From: Sharon Holman
Sent: 17 June 2021 09:04
To: planning_admin
Subject: FW: PLA0055287

Civ – WW resp

Westerdale, Hill Street, Rhosllanerchrugog, Wrexham
Development: Outline Application (All Matters Reserved) For 6 Dwellings
PLA0050992

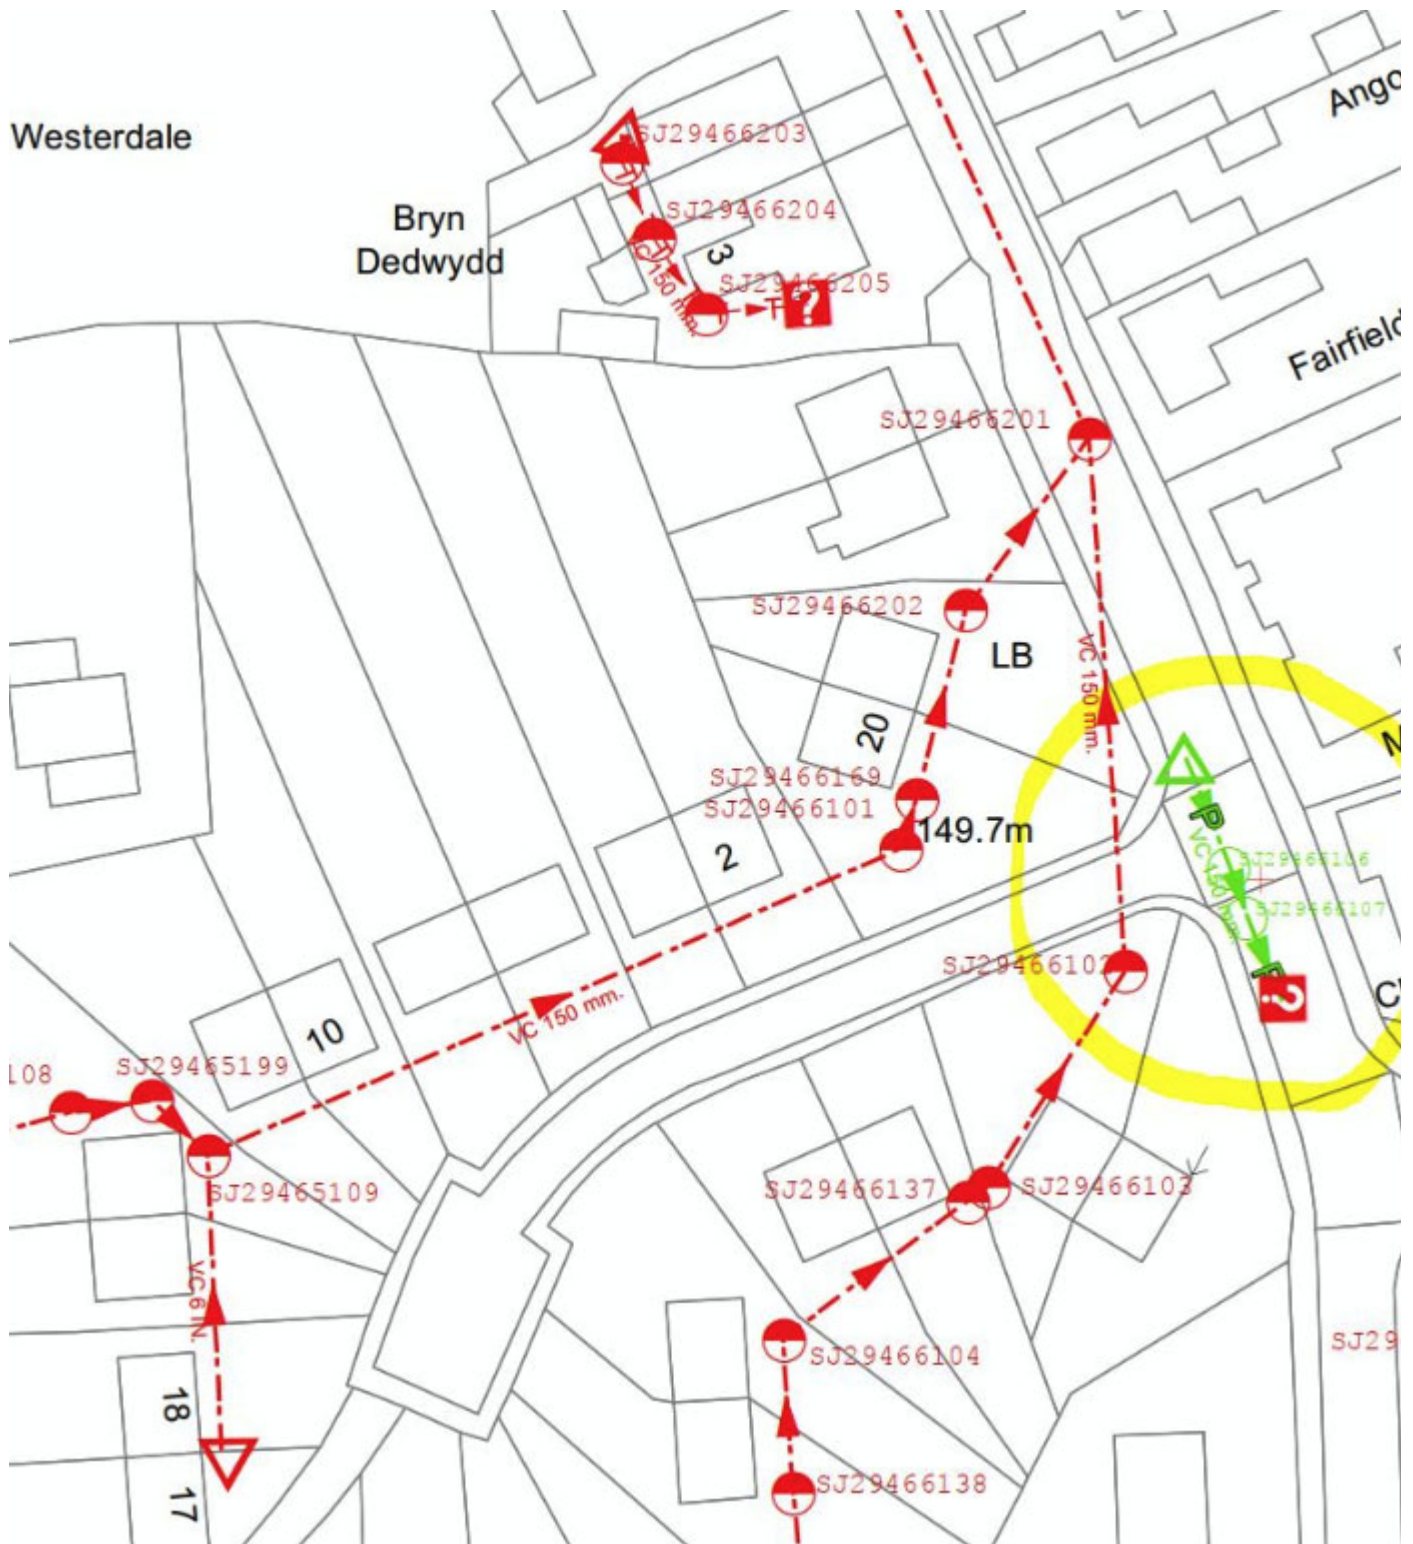
Yes I am referring to private sewer as circled below, we would support discharge to this asset in any case as long as it ultimately outfalls to a water course/drainage ditch.

Can you confirm you are referring to the private sewers circled in yellow below? We would expect these to connect into the 150 SW public sewer in Maes Y Ficerdy. If we advise the client to undertake a CCTV and this connectivity is confirmed will you be able to approve a discharge?
